Access Compliance Report Public Rights-of-Way (Curb Ramps)

Main Street: GIMBERT_LN Cross Street: SILVER_MAPLE_WAY Location: SW

ADA ID: RPRK220127133623 Ramp Type: Type 1 - Perpendicular Diagonal Initial Pass/Fail: Pass Overall Compliance: No Severity Score: 0

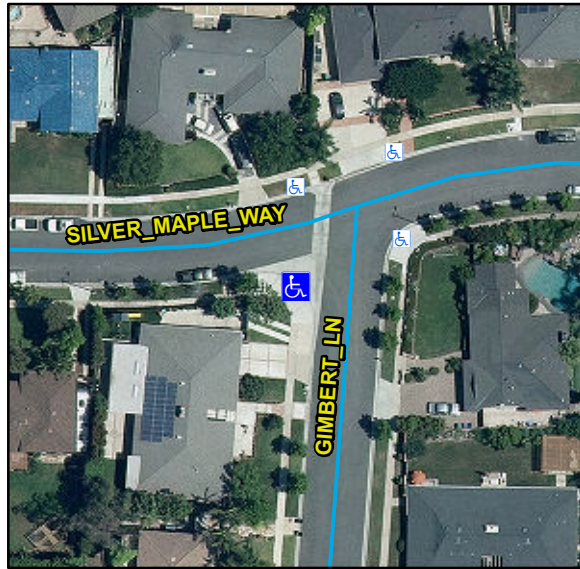
Compliance	Description	Data	Compliance	Description	Data
N/A	Ramp Length (in)	97	N/A	Flare Type LT	
Yes	Ramp Width (in)	48			Sloped
Yes	Ramp Run Slope (%)	4.5	Yes	Flare Slope LT (%)	3.4
Yes	Ramp Cross Slope (%)	1.5	N/A	Flare Traversable LT	Yes
N/A	Landing Present	Yes	N/A	Flare Type RT	
N/A	Landing Length (in)	48			Sloped
Yes	Landing Width (in)	48	N/A	Flare Slope RT (%)	5.9
No	Landing Run Slope (%)	2.3	N/A	Flare Traversable RT	No
Yes	Landing Cross Slope (%)	1.6	Yes	DWS Provided	Yes
N/A	Landing Movement Obstructed?	Yes	Yes	DWS Contrast	Yes
	Landing Movement Type	Curb	Yes	DWS Length (in)	36
N/A	Landing Shared	No	Yes	DWS Full Width	Yes
N/A	Clear Space	Yes	Yes	DWS Offset Left (in)	0
N/A	Clear Space To Crosswalk (in)	48	Yes	DWS Offset Right (in)	N/A
N/A	Marked Crosswalk 1	No	N/A	Marked Crosswalk 2	No
	Crossing 1 Direction	E		Crossing 2 Direction	N
	Marked Crosswalk 1 Width (in)	N/A		Marked Crosswalk 2 Width (in)	N/A

N/A	Ramp Inside Crosswalk 1	N/A	Yes	Ramp Inside Crosswalk 2	N/A
	Crossing 1 Slope (%)	4.1		Crossing 2 Slope (%)	7
	Crossing 1 Cross Slope (%)	0.6		Crossing 2 Cross Slope (%)	2.8
Yes	Gutter Ponding	No	Yes	Curb Slope	3.2
Yes	Gutter Lip Height (in)	0		Road Run Slope (%)	1.8
Yes	Gutter Run Slope (%)	3.2		Road Cross Slope (%)	2.1
No	Gutter Cross Slope (%)	2.6			
Yes	Overall Surface Condition: Acceptable		Yes	Perp Joint Present	Yes
	Cross Gutter Present?	Yes		Spandrel Present?	Yes
	Replace Cross Gutter?	No		Replace Spandrel?	No

Remove & Replace Landing. Remove & Replace Gutter.
